Errata to IEEE Standard Test Specification for Thyristor Diode Surge Protective Devices

Correction Sheet

Issued 23 October 2009

**Correction Sheet to
IEEE Std C62.37-1996**

Figure 17—Switching and on-state waveforms for a positive breakdown slope thyristor SPD

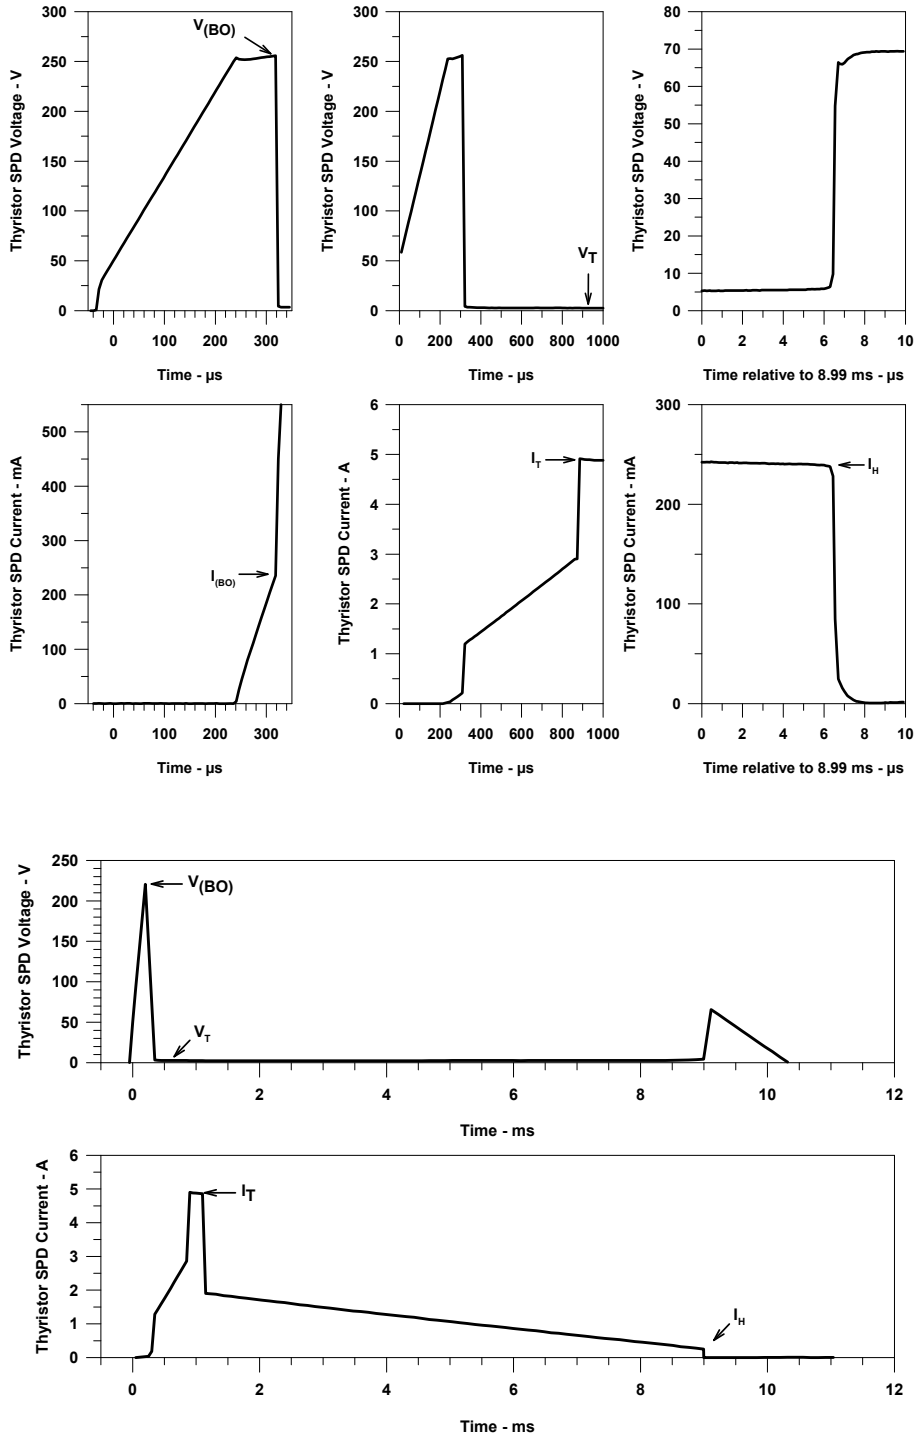
Page 23, Subclause 4.5.3, Figures 17, 18 and 19 should be as follows:

Figure 29—Thermal impedance ($Z_{\theta JA}$) vs. time

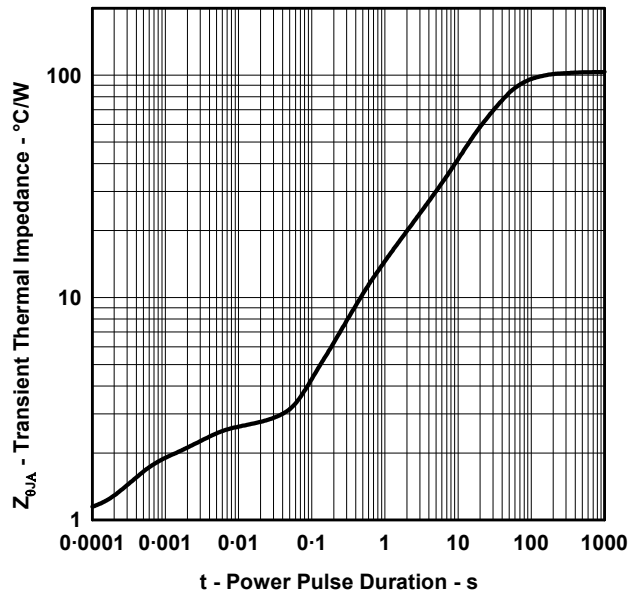
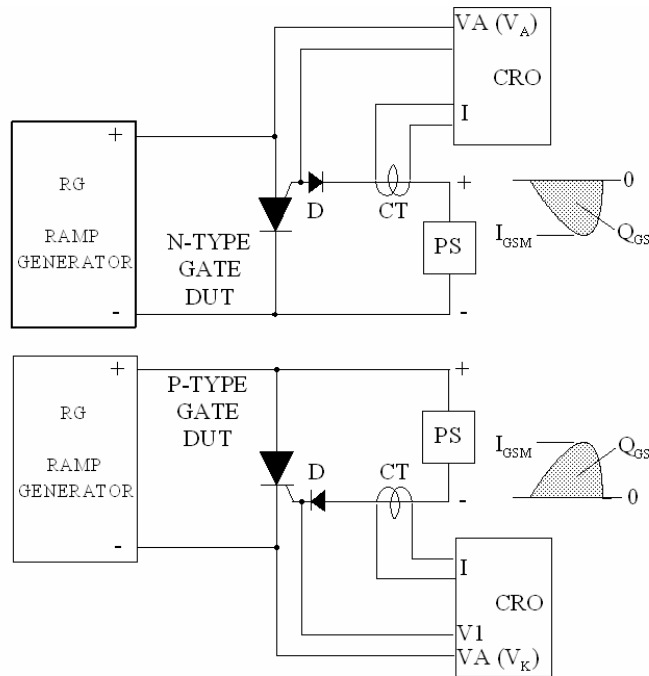
Page 35, Subclause 4.5.18, Transient thermal impedance— $Z_{\theta(t)}$, Figure 29 should be as follows:

Figure 37—Overall and expanded clamping waveforms for a p-type gate DUT to illustrate $V_{GK(BO)}$ and Q_{GS} measurement ($di_K/dt=10 \text{ A}/\mu\text{s}$)

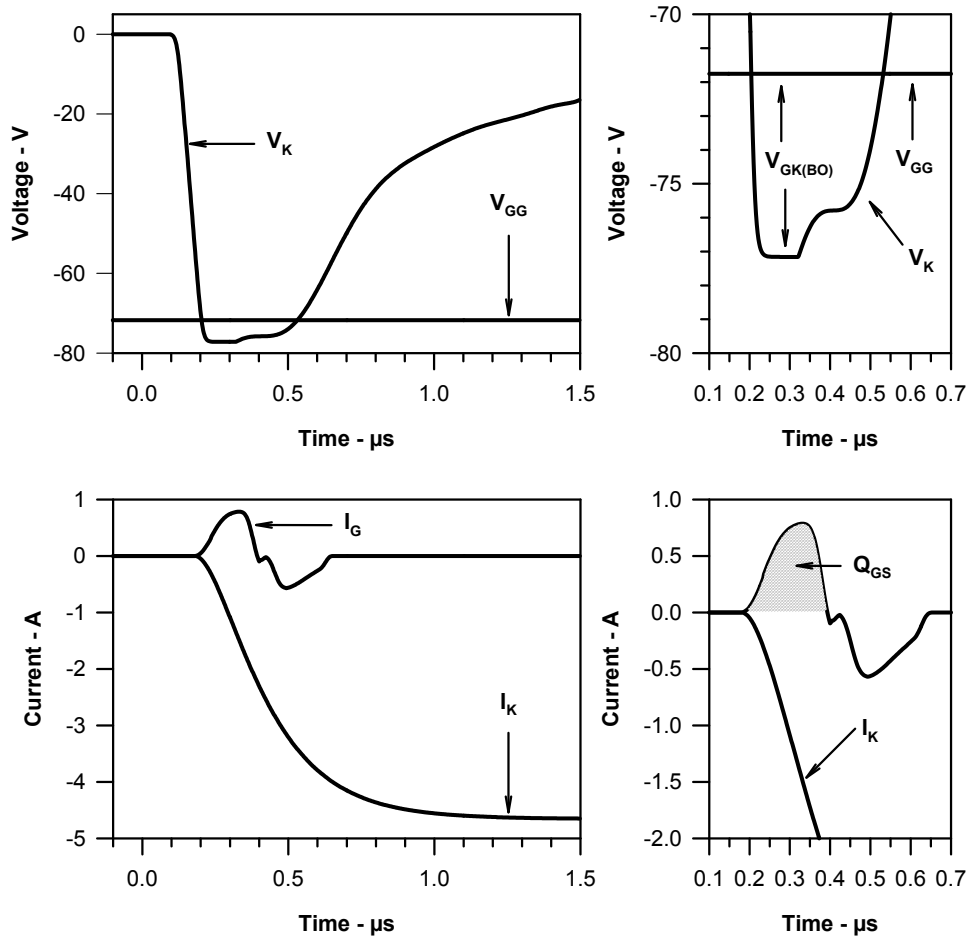
Page 42, Subclause 4.5.24, Gate switching charge— Q_{GS} , Figure 37 should be as follows:
